Access Compliance Report Public Rights-of-Way (Curb Ramps)

Main Street: VISTA_LOMA		Cross Street: ESPERANZA_RD		Location:	NE
ADA ID: RPAT210923133112	Ramp Type:Type 1 - Perpendicular	Initial Pass/Fail: Fail	Overall Compliance: No	Severity Score:	15

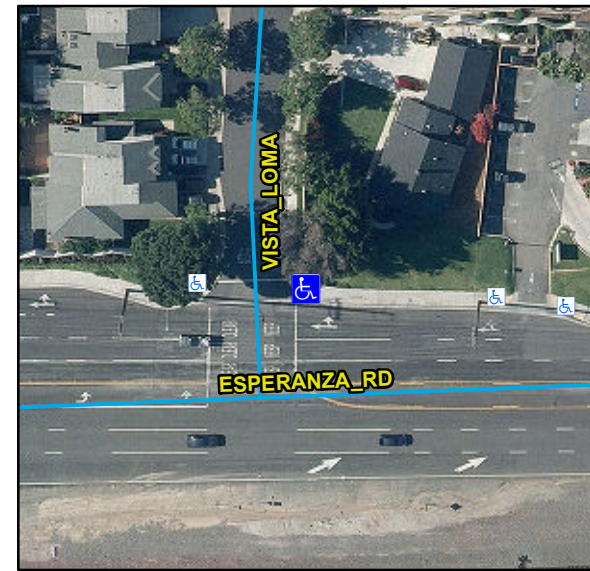
Compliance	Description	Data	Compliance	Description	Data
N/A	Ramp Length (in)	60	N/A	Flare Type LT	
Yes	Ramp Width (in)	93			N/A
No	Ramp Run Slope (%)	9.4	N/A	Flare Slope LT (%)	N/A
Yes	Ramp Cross Slope (%)	1.7	N/A	Flare Traversable LT	N/A
N/A	Landing Present	N/A	N/A	Flare Type RT	
N/A	Landing Length (in)	N/A			N/A
N/A	Landing Width (in)	N/A	N/A	Flare Slope RT (%)	N/A
N/A	Landing Run Slope (%)	N/A	N/A	Flare Traversable RT	N/A
N/A	Landing Cross Slope (%)	N/A	N/A	DWS Provided	N/A
N/A	Landing Movement Obstructed?	N/A	N/A	DWS Contrast	N/A
	Landing Movement Type	N/A	N/A	DWS Length (in)	N/A
N/A	Landing Shared	N/A	N/A	DWS Full Width	N/A
N/A	Clear Space	N/A	N/A	DWS Offset Left (in)	N/A
N/A	Clear Space To Crosswalk (in)	N/A	N/A	DWS Offset Right (in)	N/A
N/A	Marked Crosswalk 1	Yes	N/A	Marked Crosswalk 2	N/A
	Crossing 1 Direction	W		Crossing 2 Direction	N/A
	Marked Crosswalk 1 Width (in)	120		Marked Crosswalk 2 Width (in)	N/A

N/A	Ramp Inside Crosswalk 1	Yes	Yes	Ramp Inside Crosswalk 2	N/A
	Crossing 1 Slope (%)	0.5		Crossing 2 Slope (%)	N/A
	Crossing 1 Cross Slope (%)	1.3		Crossing 2 Cross Slope (%)	N/A
N/A	Gutter Ponding	N/A	No	Curb Slope	10.3
Yes	Gutter Lip Height (in)	0		Road Run Slope (%)	N/A
N/A	Gutter Run Slope (%)	N/A		Road Cross Slope (%)	N/A
N/A	Gutter Cross Slope (%)	N/A			
Yes	Overall Surface Condition: Acceptable		Yes	Perp Joint Present	Yes
	Cross Gutter Present?	No		Spandrel Present?	No
	Replace Cross Gutter?	N/A		Replace Spandrel?	N/A

Remove & Replace Entire Ramp.

R304.2.2, STD 1115
